## Morecambe Offshore Windfarm: Generation Assets Procedural Deadline A

### The Applicant's Response to Relevant Representations

Document Reference: 8.3

**Figure:** 1      **Drawing No:** PC1165-RHD-ES-OF-DG-Z-0162

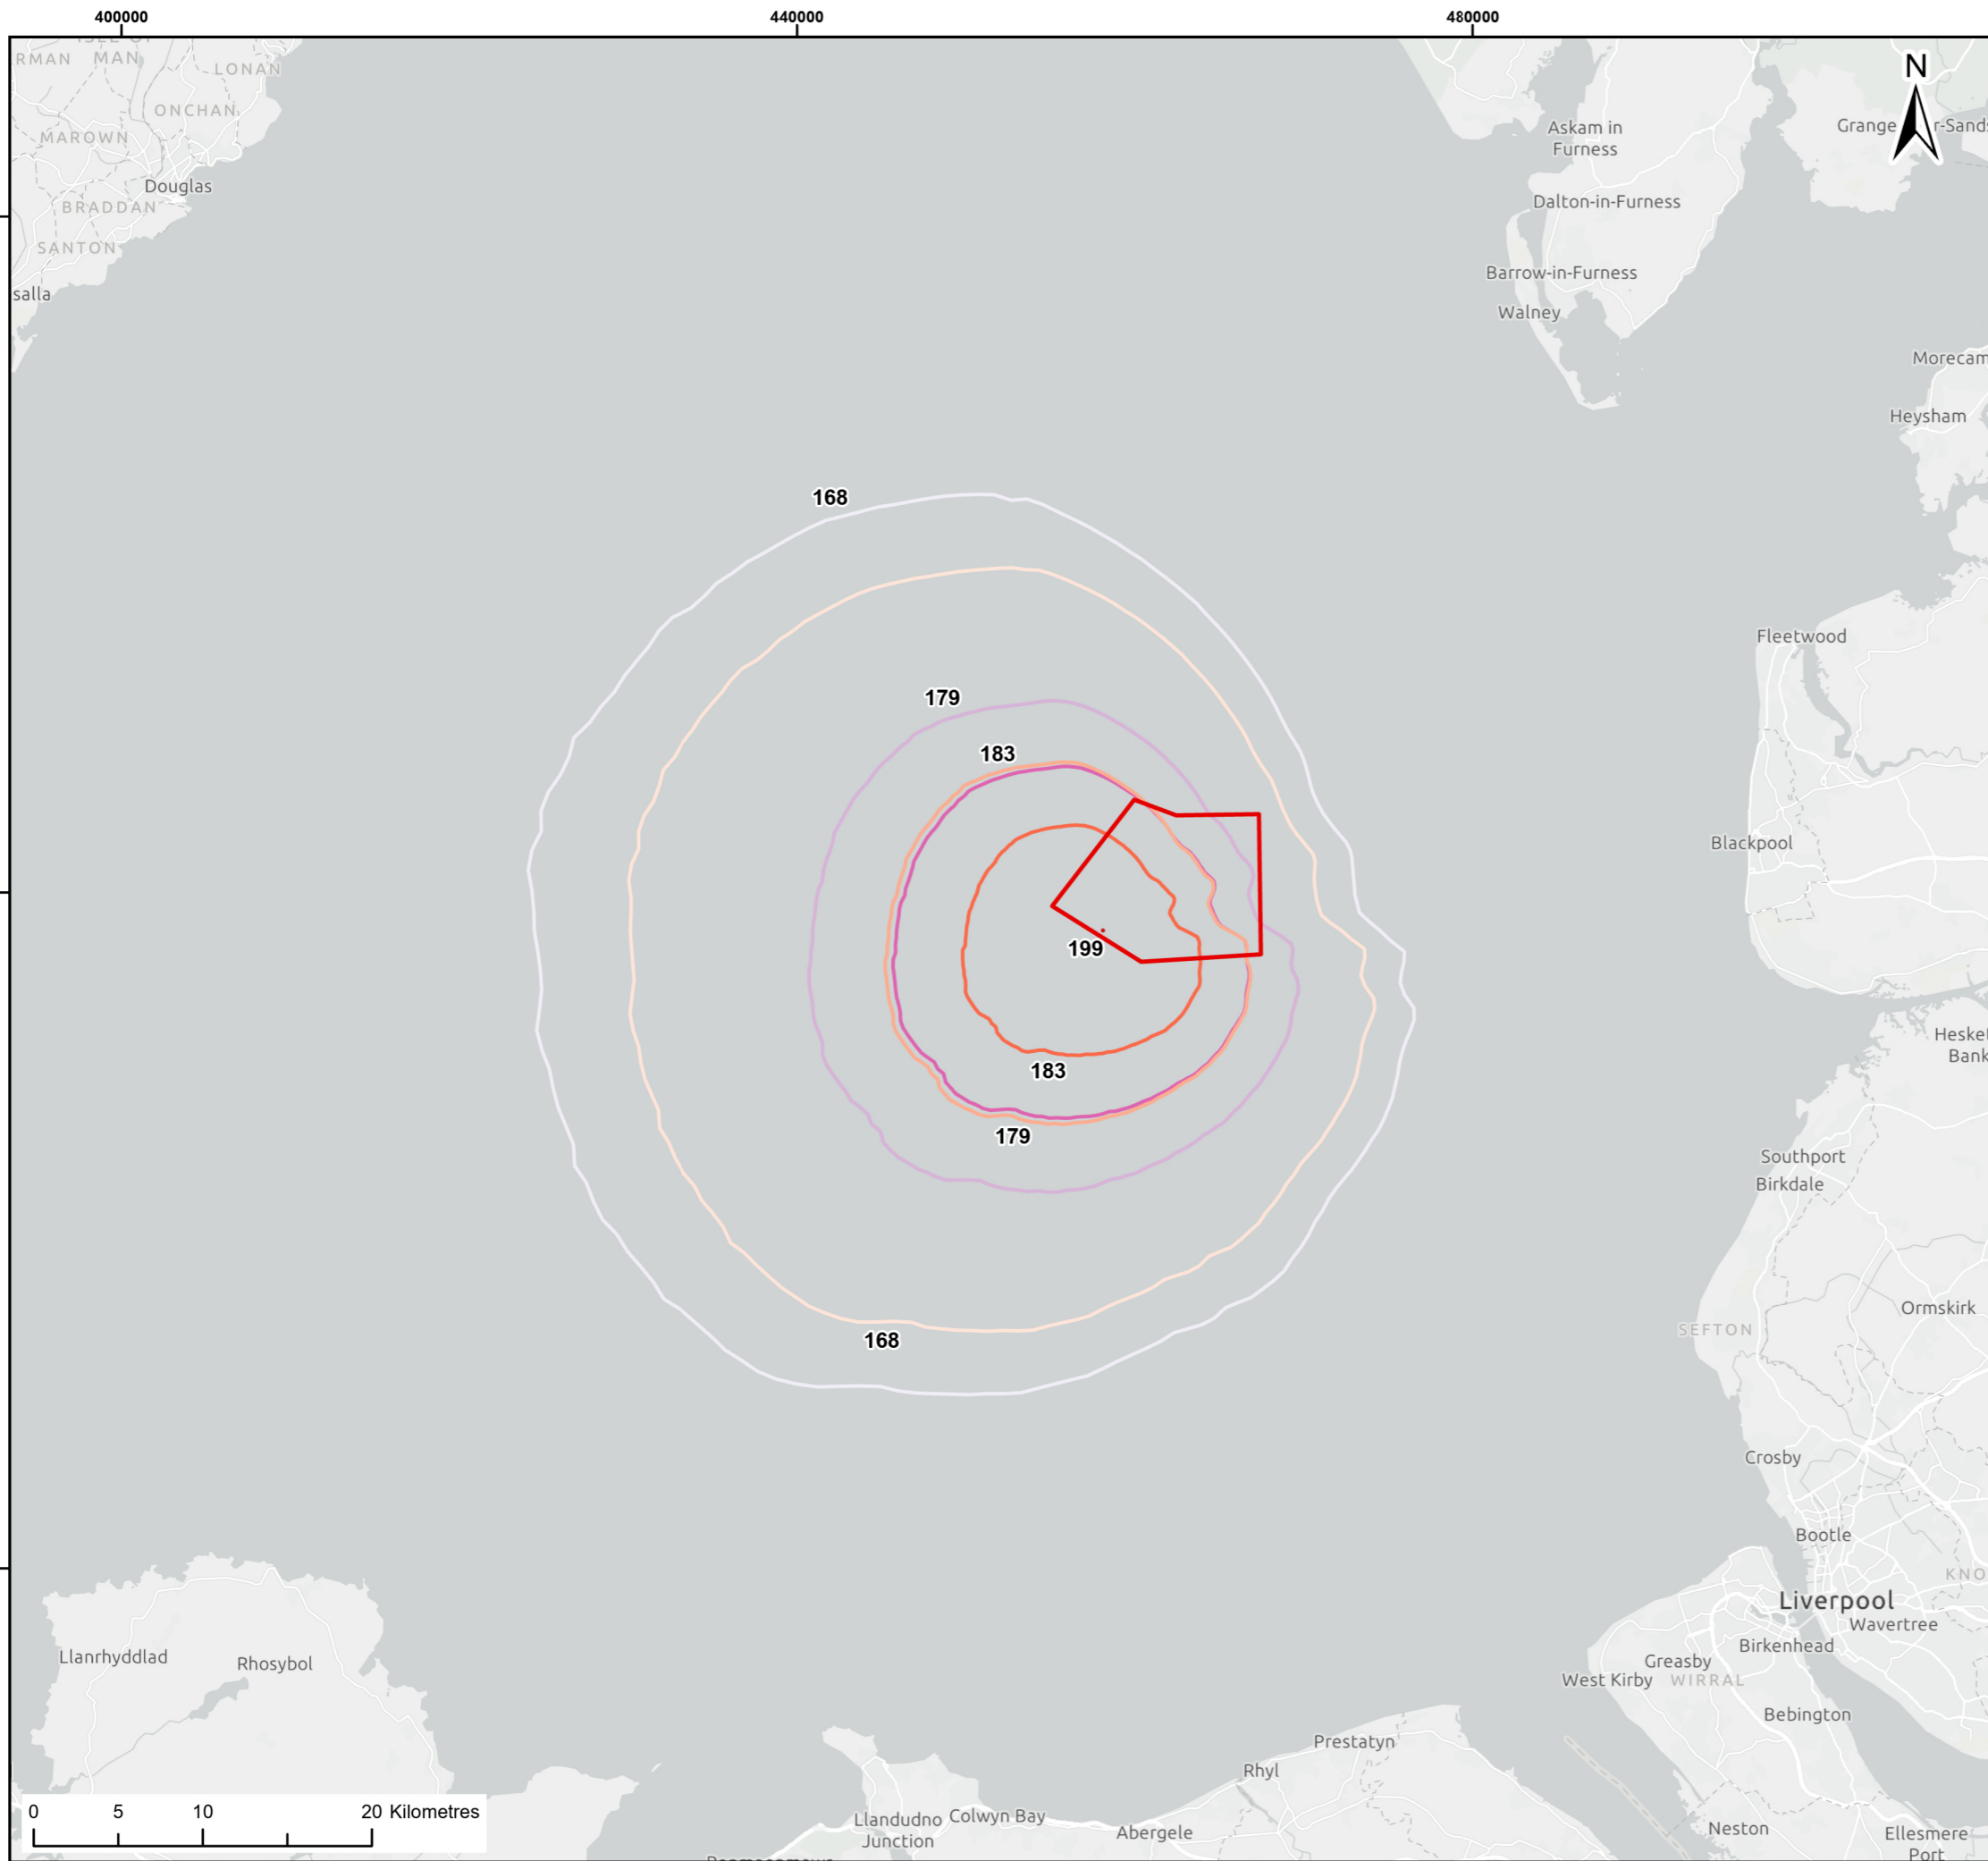
RR-061-257	<p><b>Natural England's Detailed Advice and Recommendations – Subtidal Benthic Ecology</b></p>	<p>Detailed responses (or signposts to the relevant responses in another section) are provided in RR-061-258 – RR-061-264.</p>

ID	RR	Applicant's Response
	<p><b>Project Parameters - Project Description - Document Used: [APP-042] 5.1.5, Chapter 5: Project Description (Ref F6)</b></p> <p>We advise that further detail is required in the project description to inform the Maximum Design Scenario (MDS) and Environmental Impact Assessment (EIA). Please see detailed comments in relevant headings of this table.</p>	
RR-061-258	<p><b>Natural England's Detailed Advice and Recommendations – Subtidal Benthic Ecology</b></p> <p><b>Project Parameters -Natural England's Position on Worst Case Scenario or Scenarios - Document Used: [APP-042] 5.1.5, Chapter 5: Project Description - (Ref F7)</b></p> <p>Cable/pipeline crossings – Natural England notes that information pertaining to cable protection volumes for cable/pipeline crossings is unclear.</p> <p>In [MOR001-FLO-CON-ENV-RPT-1050] paragraph 5.73 notes that “Cable protection would be required at the crossings (and is additional to the cable protection requirements set out in Table 5.12)”. Table 5.13 sets out the cable/pipeline crossings design envelope and includes maximum cable/pipeline crossing volume per crossing (m3), and maximum cable/pipeline crossing volume for all crossings (m3). However, it is not explicit that these volumes relate to cable protection. Additionally, there is no information on location of crossings. It would be helpful if these could be provided and updated in the final ES. To better understand any potential disruption to benthic habitats, Natural England advises that further information on cable crossings is provided in line with best practice guidance as set out in Natural England's Best Practice Guidance Phase III. Namely:</p> <ul style="list-style-type: none"> <li>▪ Method(s) to be used;</li> <li>▪ Specific locations (informed by acoustic data);</li> </ul>	<p>Please see detailed response to RR-061-244 for a response to cable protection requirements at cable crossings and a response to the bullets listed in NE's Best Practice Guidance Phase III.</p>

**Figure:** 2a      **Drawing No:** PC1165-RHD-ES-OF-DG-Z-0157

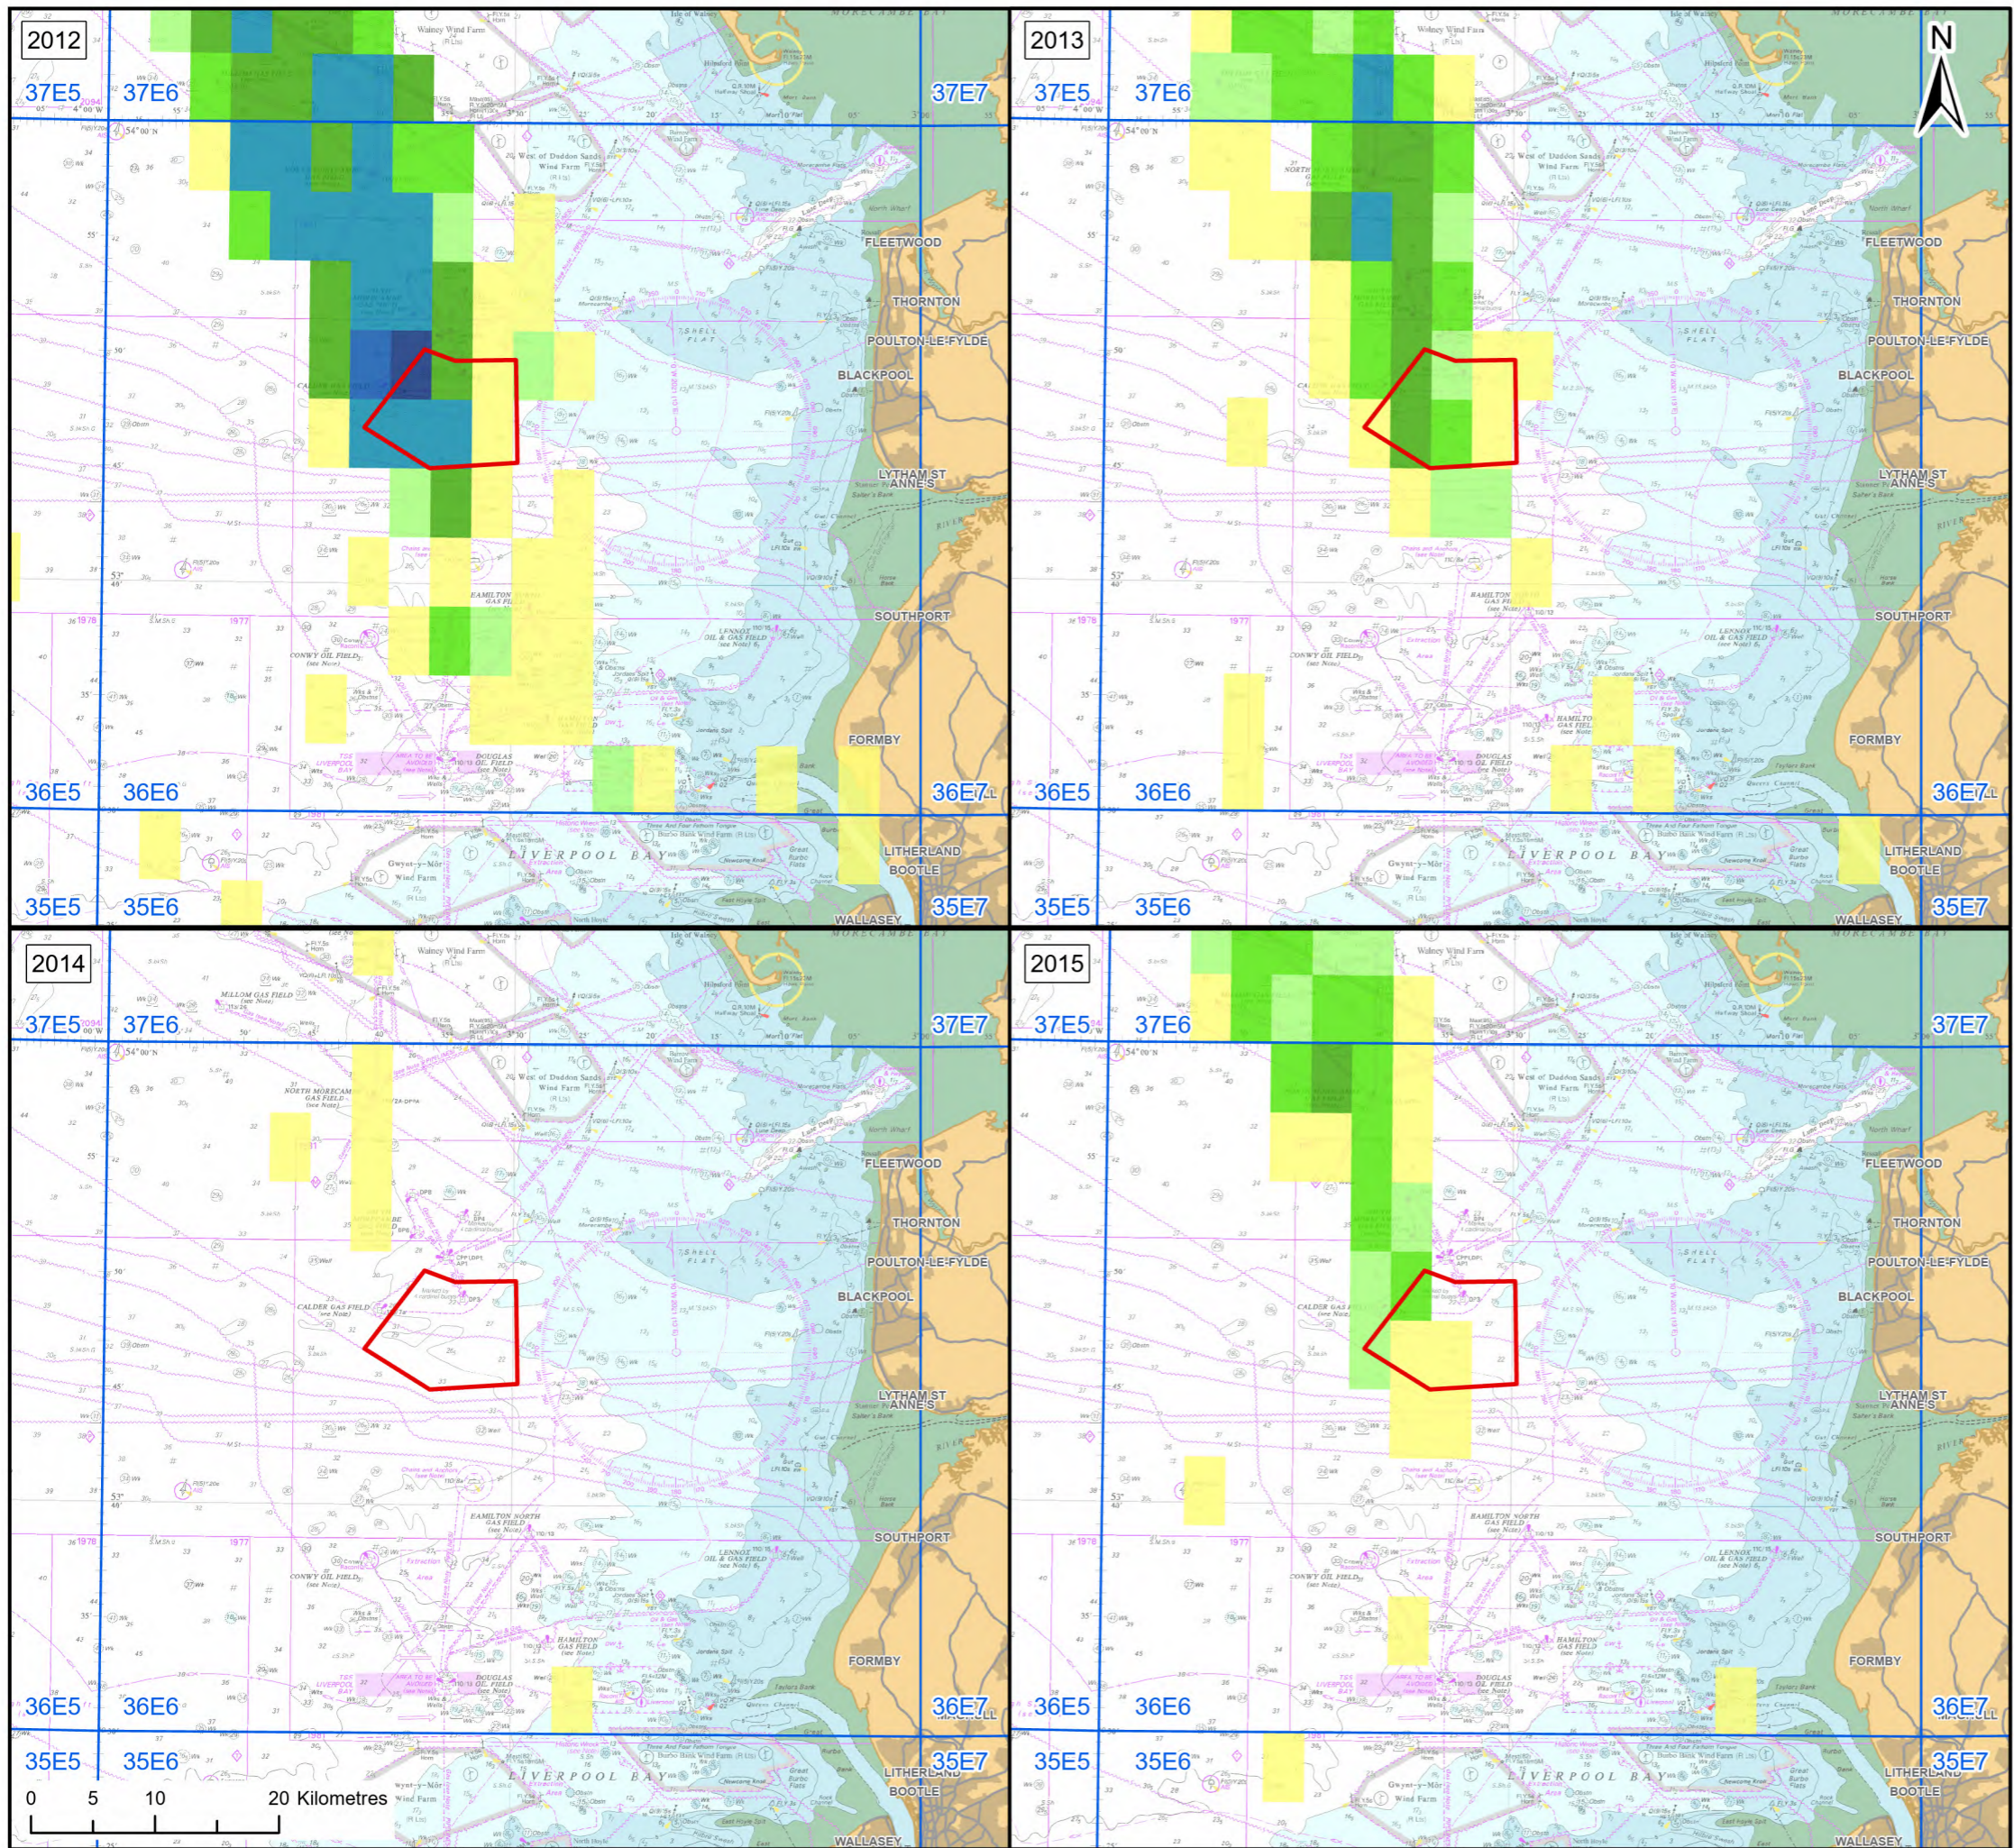
ID	RR	Applicant's Response
		<p>The Applicant remains of the position that this assessment is valid, with further justification provided below.</p>
AS-011-02	<p>The Morecambe ICES rectangle 36E6 and surrounding area is an important area for the BE fisheries. Between 2019 and 2023 the landings of the area was on average 136 ton which account for at least 1% of the annual turnover of the Belgian fleet The agency notices that the cited data used in the technical report were from 2012 to 2016, which are not recent data and does not reflect the current activity and importance of the area for the Belgian fisheries. Furthermore recent data suggest the opposite of the cited data and show quite high steady fisheries activity with some fluctuation but no sign of decrease.</p>	<p>The Applicant would like to highlight Figure 4.2 of Appendix 13.1 Commercial Fisheries Technical Report (APP-072) which presents surface swept area ratio data for European Union (EU) beam trawls, including United Kingdom (UK) and Belgian Vessel Monitoring System (VMS) data based on an annual average from 2016 to 2020. The spatial data indicates that beam trawl activity occurs within 36E6, including occasional activity within the Project and higher intensity fishing by beam trawling outside and to the north and north-west of the Project.</p> <p>The spatial activity of the EU beam trawl fleet was presented to the Belgian Producers Organisation, Rederscentrale during a pre-application consultation meeting (6<sup>th</sup> December 2023), and considered representative of the Belgian activity at that time.</p> <p>The Applicant highlights that the Morecambe windfarm site is an area of 87km<sup>2</sup> and overlaps with 2.4% of International Council for the Exploration of the Seas (ICES) rectangle 36E6 (which is 3,668.2km<sup>2</sup> in area). To further examine activity across 36E6, the Applicant has mapped the EU beam trawl VMS data annually from 2012 to 2020 indicating the fishing effort (kilowatt-hour (kWh)) by c-square. This data is presented in <b>Figure 2a</b> and</p>

ID	RR	Applicant's Response
		<p><b>Figure 2b</b> below this RR response. The data further demonstrates the higher intensity activity to the north and north-west of the Project. Based on analysis of the fishing effort within 36E6 on average, approximately 8% of the EU (including UK) beam trawl fishing intensity within 36E6 occurs within the Project boundaries (based on a 9 year average from 2012 and 2020).</p> <p>As secured by the Fisheries Co-existence and Liaison Plan (FLCP), with an outline submitted within the Development Consent Order (DCO) Application (APP-147), the Applicant is committed to updating the fishing industry, including Rederscentrale, on the timing and location of any construction works. Fishers would not be prohibited from entering the site, with exception of Safety Zones around infrastructure under construction and major maintenance activities.</p> <p>The Applicant considers the impact assessment and conclusions for the Belgian beam trawl fleet to remain valid, as set out in Chapter 13 Commercial Fisheries (APP-050).</p> <p>The Applicant would welcome further data on the Belgian beam trawl spatial activity and landings. While landings data for period 2012 to 2016 is recognised as historic (landings data for non-UK vessels was not available post-2016 by ICES rectangle), it has been supplemented with spatial VMS data up to 2020.</p>
